SUBJECT: ISSUANCE OF AMENDMENT TO FACILITY OPERATING LICENSE NO. DPR-18

ROCHESTER GAS AND ELECTRIC CORPORATION
DOCKET NO. 50-244
R. E. GINNA NUCLEAR POWER PLANT
AMENDMENT TO FACILITY OPERATING LICENSE

Amendment No. 36
License No. DPR-18

SAFETY EVALUATION BY THE OFFICE OF NUCLEAR REACTOR REGULATION
SUPPORTING AMENDMENT NO. 36 TO FACILITY OPERATING LICENSE NO. DPR-18

FIGURE 3.10-1
CONTROL ROD INSERTION LIMITS VERSUS CORE POWER
FOR BOL THROUGH EOL

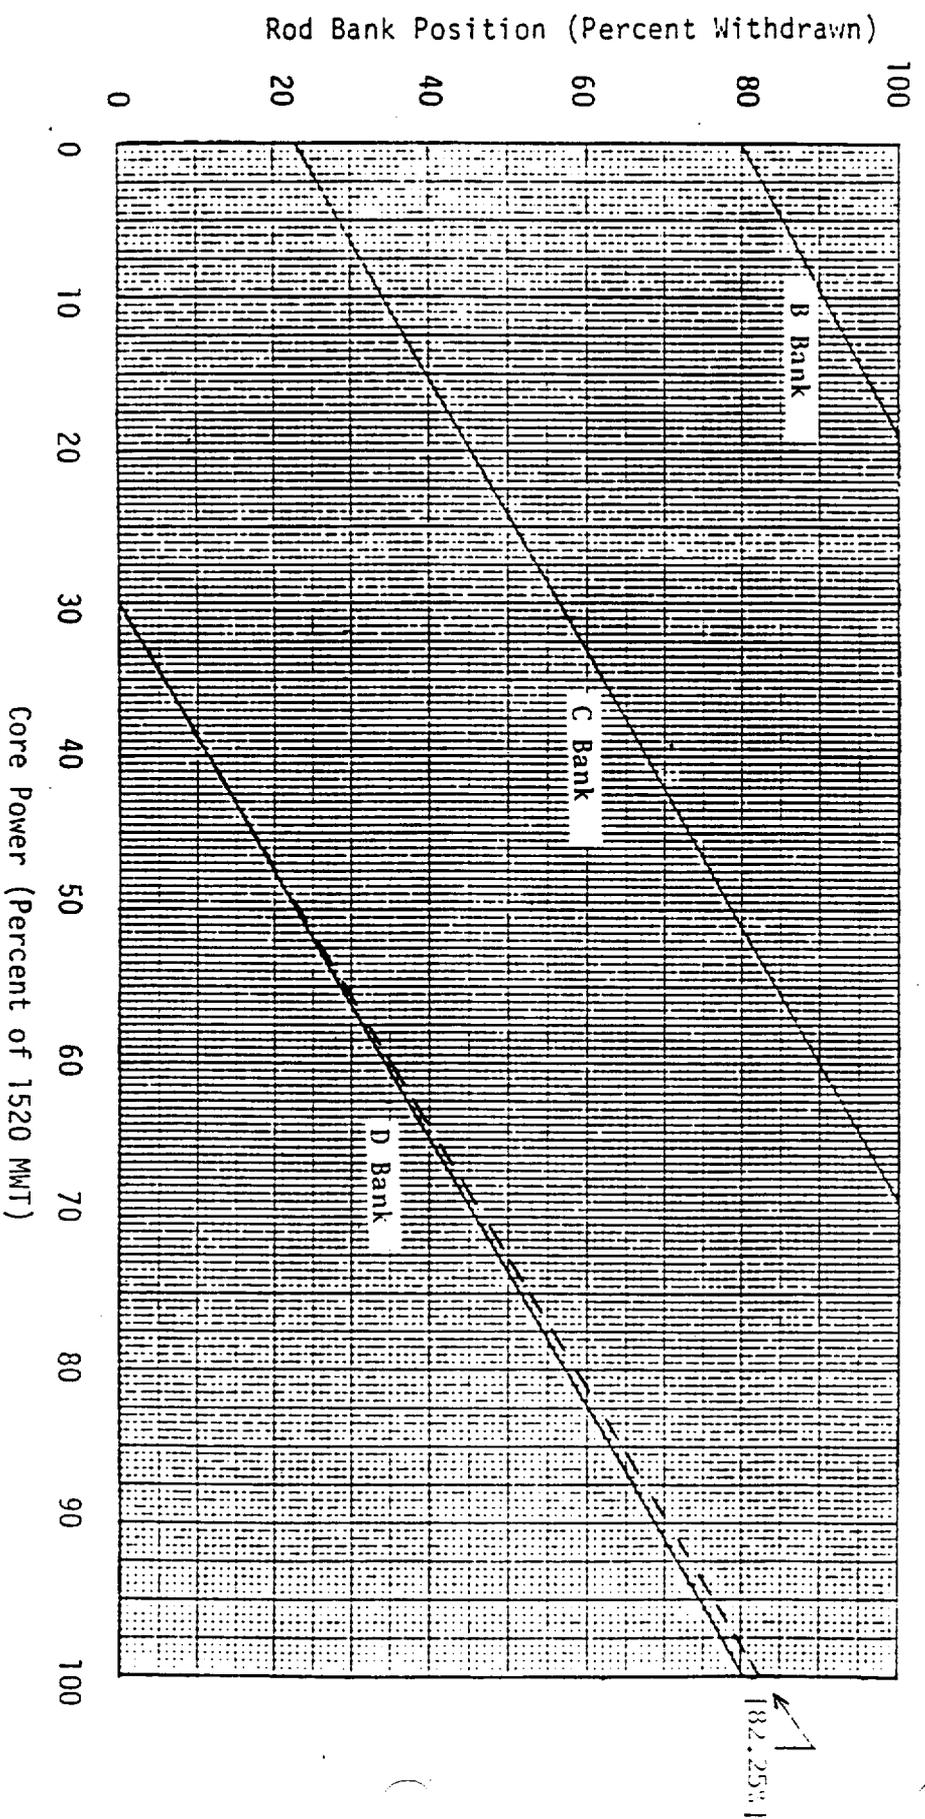
[----- Dashed line is applicable only for Cycle 19 with cycle burnup greater than 5250 MWD/MTU providing Cycle 18 burnup has exceeded 12150 MWD/MTU.]

The Cycle 19 reload has been designed by Westinghouse using standard design methodology. Based on this methodology, all criteria for the reload are met provided a slight adjustment is made to the bank D insertion limits. This Technical Specification change will slightly modify the rod insertion limits for Cycle 19 to ensure all criteria are met.

The adjustment is only necessary for Cycle 19, since Cycle 18 exceeded a burnup of 12150 MWD/MTU, and is only applicable for Cycle 19 burnups from 5250 to 9500 MWD/MTU. (Since 9500 MWD/MTU is close to Cycle 19 end of cycle, the 9500 burnup has been extended to end of cycle for this application).

The amount by which the 1.66 FW limit could be exceeded with the current insertion limits varies from 0% at a Cycle 18 burnup of 12150 MWD/MTU to a maximum of 0.33% at a Cycle 18 burnup of 12300 MWD/MTU. The limit is not exceeded if the bank D insertion limit is raised by 2.25% (5 steps) at full power. Since this change is not applicable to future cycles, it is a change with a limited period of applicability with appropriate qualifiers. No other safety criteria are affected by the Cycle 19 core reload.

The proposed change would require the bank D control rods to be withdrawn 5 steps farther during full power operation. Withdrawing the rods above the insertion limit increases the shutdown margin, decreases the ejected rod worth, reduces power peaking, and does not alter stuck rod worth. Therefore, withdrawing the rods is conservative and ensures that the safety criteria for the Cycle 19 reload are met, there is no significant increase in the probability or consequences of an accident previously evaluated. Thus the staff finds the proposed change acceptable for Cycle 19.
